Statement of Common Ground between Wyre Forest District Council and the Environment Agency

This SofCG has been produced to support the submission of the Wyre Forest District Local Plan (2016 – 2036). It sets out how Wyre Forest District Council has engaged with the Environment Agency in order to fulfil its Duty to Cooperate requirements.

**Wyre Forest District Local Plan Review – Pre-Submission Publication
Consultation (Regulation 19)**

Wyre Forest District Local Plan Review (October 2018) – Pre-submission Consultation

Appendix A:

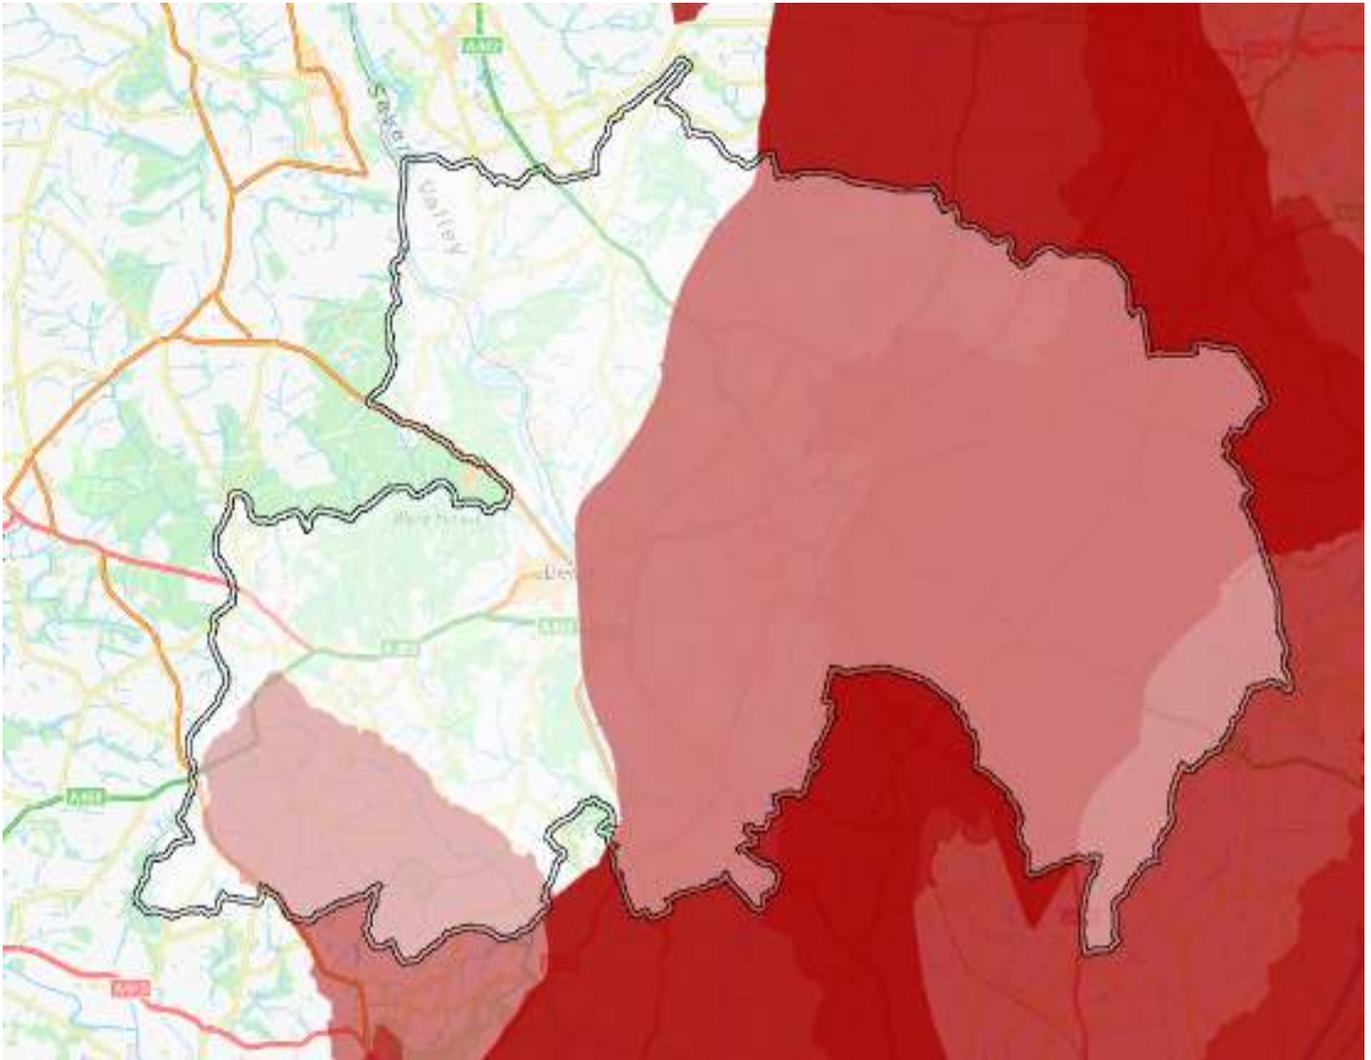
<p>to secure net gains for biodiversity, and other environmental improvements, in line with the NPPF recent revisions.</p> <p>Note – Please see current government consultation on ‘net gains key issues’ which is seeking to pursue a broader Environmental Net Gain approach. https://consult.defra.gov.uk/land-use/net-gain/</p>
<p>Environment Agency (2018 response)</p>	<p><u>Policy 15A – Water Conservation and Efficiency</u></p> <p>The EA note that a policy has been included to secure higher (more stringent) levels of water efficiency for residential development throughout the district.</p> <p>In line with the approach for justifying higher levels of water efficiency policies, the EA have recently produced mapping which show areas of water stress and/or catchments that are likely failing due to low flows. This is within appendix A of the EA response for information/inclusion within the Water Cycle Study evidence. It should be noted that whilst this does not cover the whole area, it covers most of Wyre Forest district (covering the east of the district). WFDC may want to secure higher water efficiency throughout the district as proposed in the policy to help achieve this water resource reduction objective. Note – primary sources of evidence which might support higher water efficiency standards for new dwellings are detailed in appendix A of the EA 2018 consultation response. The EA map is collated based on the following sources: Water Stressed Areas Classification (2013), Water resource management plans produced by water companies, River Basin Management Plans. Please see ‘Appendix A’ – Map and note on Water Resource and Efficiency.</p>

Figure 2-1 Location of newly identified sites

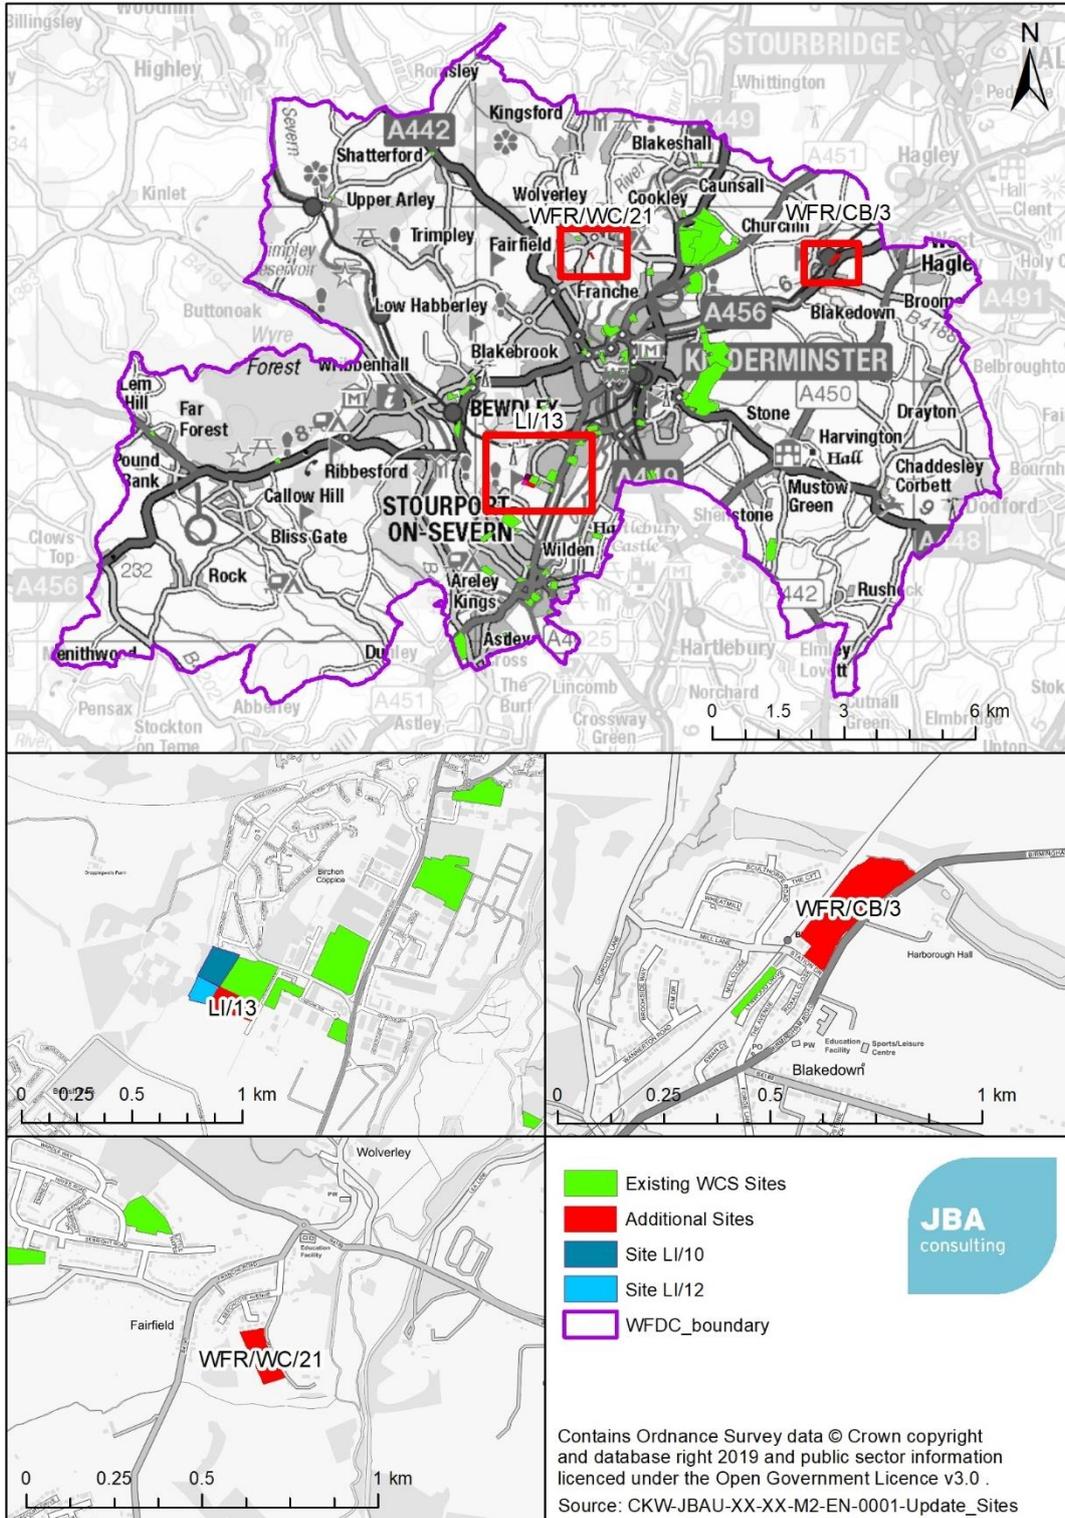
The site does not appear to have been assessed within the Water Cycle Study (WCS) and therefore it is unclear whether the proposed housing growth can be accommodated in consideration of waste water infrastructure. Information on local treatment works and their ability to accommodate housing and employment growth are included within the WCS. We recommend your Council identifies the receiving sewage treatment works and whether the housing can be accommodated without impacting upon the receiving treatment works. You should look at physical capacity issues (e.g. network pipes) in consultation with the Water Company; and environmental capacity (quality of treated effluent) issues.

<p>Environment Agency (2019 response)</p>	<p><u>Policy AM36.11 – Land off Station Drive, Blakedown, WFR/CB/3</u></p> <p>The EA note site WFR/CB/3 is allocated for</p>	<p>WFDC has updated the Water Cycle Study (WCS) following these comments from the EA. The updated WCS can be viewed in Appendix 5 of this SofCG and includes the</p>
